SERVICE INFORMATION NO. SI 40-083

GARMIN: Service Bulletin No. 0823
ATA-Code: 34-00

NO.: 0823

SUBJECT: GDU 104X CRS/BARO Knob Interference

Figure 1

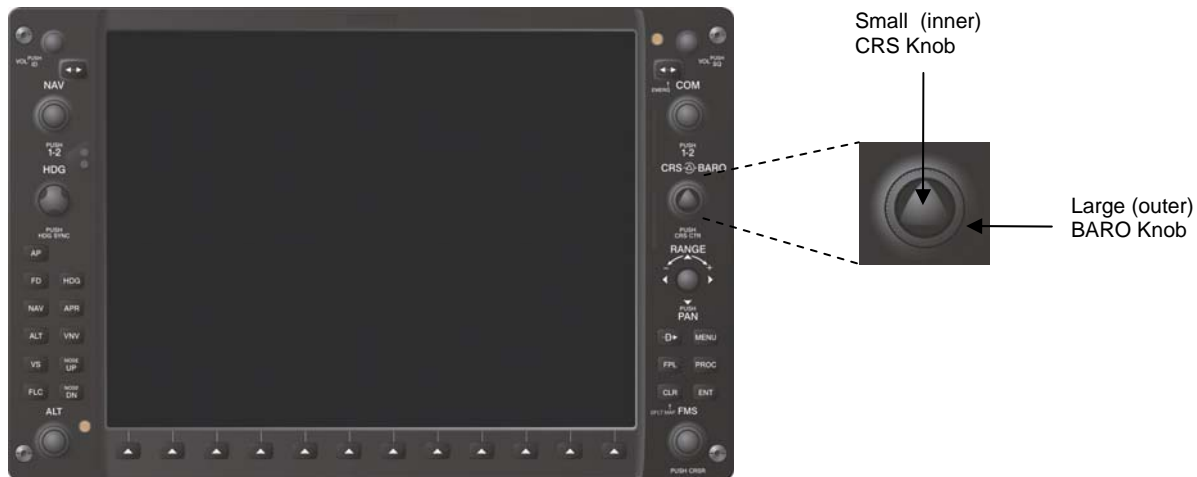
Garmin has identified an issue, whereby the large (outer) BARO knob and the small (inner) CRS knob may interfere with each other.

1. Apply power to the G1000/G900X/G950.
2. Press the CDI softkey on the Primary Flight Display(s) (PFD) to enter VOR mode on the HSI.
3. Rotate the large (outer) BARO knob (refer to Figure 1) a minimum of three complete revolutions in each direction while monitoring the Horizontal Situation Indicator/Digital Course Indicator (refer to Figure 2) on the PFD. If a change in the Horizontal Situation Indicator/Digital Course Indicator is produced while turning the BARO knob proceed to the Modification Instructions.

4. Rotate the small (inner) CRS knob (refer to Figure 1) a minimum of three complete revolutions in each direction while monitoring the Barometric Altimeter Setting (refer to Figure 2) on the PFD. If a change in the Barometric Altimeter Setting is produced while turning the CRS knob proceed to the Modification Instructions.
5. Repeat Steps 3 and 4 for each affected GDU.

If CRS/BARO Knob interference is confirmed, perform the steps below to replace the CRS/BARO Knob. New knobs can be obtained through a Garmin Service Center or Aircraft OEM under Garmin part number K00-00446-00.

1. Grasp the small (inner) CRS knob and firmly pull the knob off the shaft.
2. Discard knob.
3. Grasp the large (outer) BARO knob and firmly pull the knob off the shaft.
4. Discard knob.

Figure 3

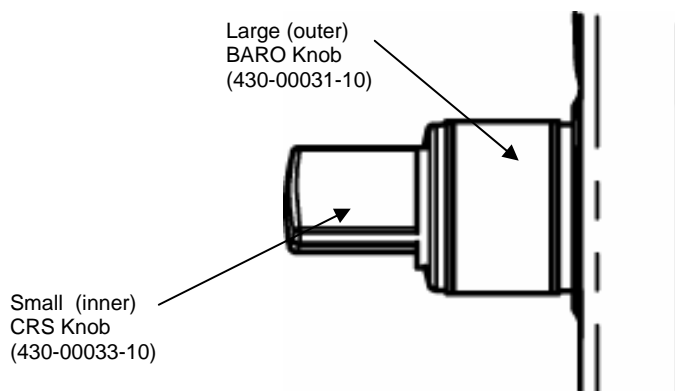
5. Grasp the large (outer) BARO knob (insuring proper orientation) and place it over the shaft.
6. Align the flat side of the knob insert with the flat side of the shaft.
7. Press down firmly to ensure knob is completely seated, refer to Figure 3.
8. Grasp the small (inner) CRS knob (insuring proper orientation) and place it over the shaft.
9. Align the flat side of the knob insert with the flat side of the shaft.
10. Press down firmly to ensure knob is completely seated, refer to Figure 3.
11. Perform the CRS/BARO Knob Interference Test (contained in the TESTING PROCEDURE section) again to confirm there is no interference.
12. Accomplish aircraft logbook entry to return aircraft to service in compliance with this service bulletin.
